# PD Modification Application: MM 22-0686

Zoning Hearing Master Date: December 12, 2022

**Hillsborough  
County Florida**

Development Services Department

## 8.2 Proposed Site Plan (Full)

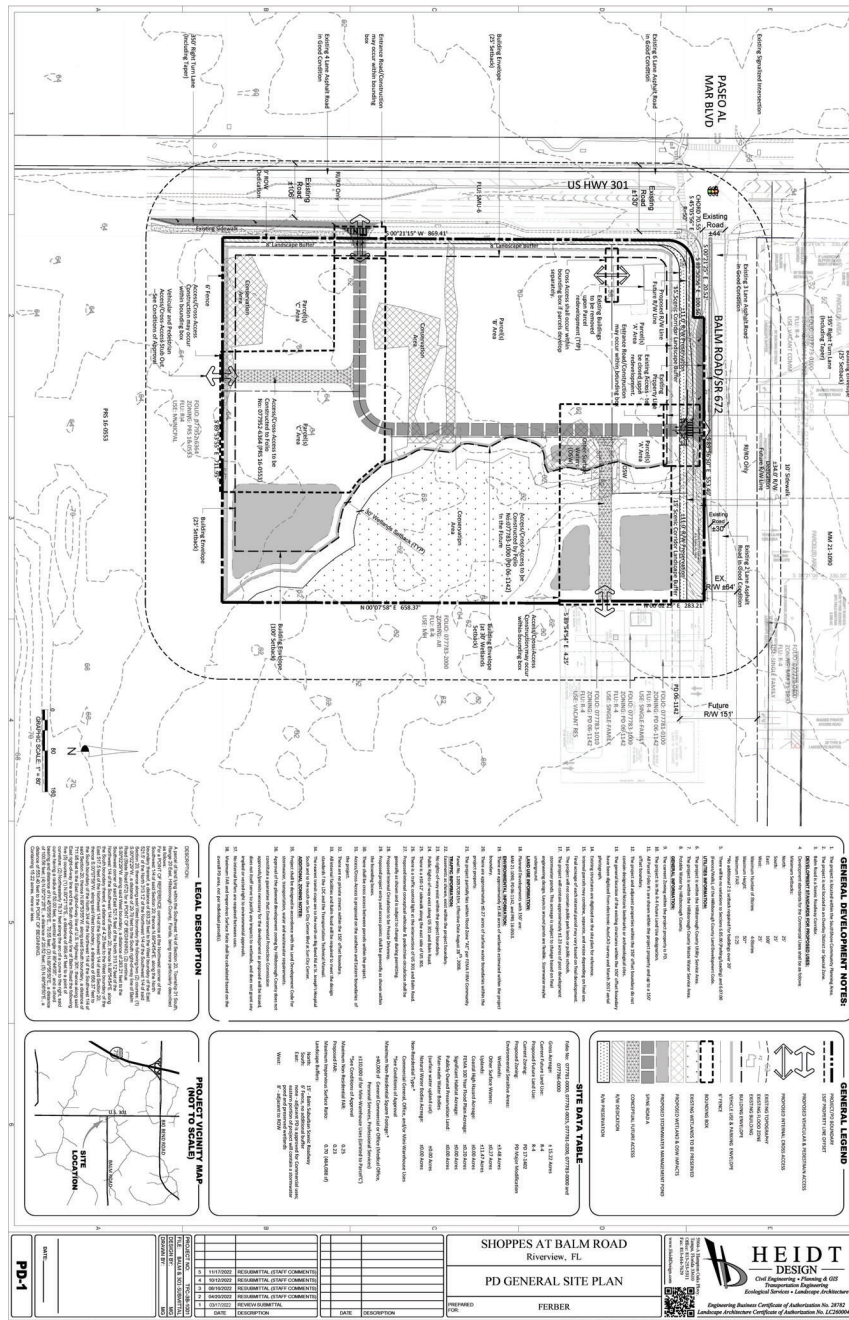
1. General Development Note #4 to correct the maximum FAR to 0.23.
2. General Development Note #27 to be modified. Changes to the internal vehicular and pedestrian circulation are not subject to change during permitting. Limited flexibility in general compliance with the depicted internal vehicular and pedestrian circulation is permitted.

3. Prior to PD site plan certification, the developer shall:
  - 3.1 Modify the label(s) reading “+/- 11’ R/W Preservation” to read “+/- 11-foot Right-of-way Preservation Consistent with Hillsborough County Corridor Preservation Plan”;

- 3.2 Modify the label(s) reading “+/- 34.0’ R/W Dedication Future R/W Line” to read “+/- 34-foot Right-of-Way Dedication and Conveyance to Hillsborough County for Site Access Improvements and Consistent with the Hillsborough County Corridor Preservation Plan”.

- 3.3 Remove the linework, arrows and affiliated note which states “Cross Access shall occur within bounding box if parcels develop separately.” As discussed with the applicant, staff notes there is insufficient detail for staff to support such restrictions, and which could result in Parcel A being landlocked.

- 3.6 Modify the access/cross-access geometry, pond locations, and stubout/connection location as shown in the graphic below, and remove the existing arrow and portions of the driveway conflicting with the new geometry. Staff notes that this revised location corresponds to the approved location within adjacent PD 06-1142).

- 3.7 Modify Note 29 to indicate, subject to additional zoning condition restrictions.
  - 3.8 Modify Note 33 to correct typo and eliminate reference to Balm Rd. Staff notes that Balm Rd. improvements are subject to a Design Exception request which, if approved, will waive strict technical manual compliance for certain technical standards.

- 3.9 Modify the Site Data Table to eliminate the references to “Office” uses. Staff notes that Commercial General (CG) uses already allow office, and so this inclusion is duplicative and confusing. Also, the footnotes stating “See Conditions of Approval” under “Non-Residential Type” and “Maximum Non-Residential Square Footage” shall be modified to instead state “Subject to Compliance with Trip Generation Caps – See Conditions of Approval”.

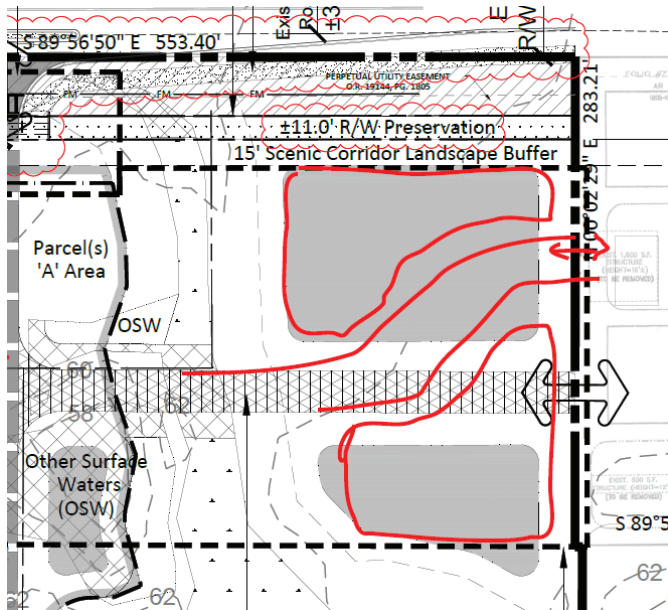
- Modify the access/cross-access geometry, pond locations, and stubout/connection location as shown in the graphic below, and remove the existing arrow and portions of the driveway conflicting with the new geometry. Staff notes that this revised location corresponds to the approved location within adjacent PD 06-1142).
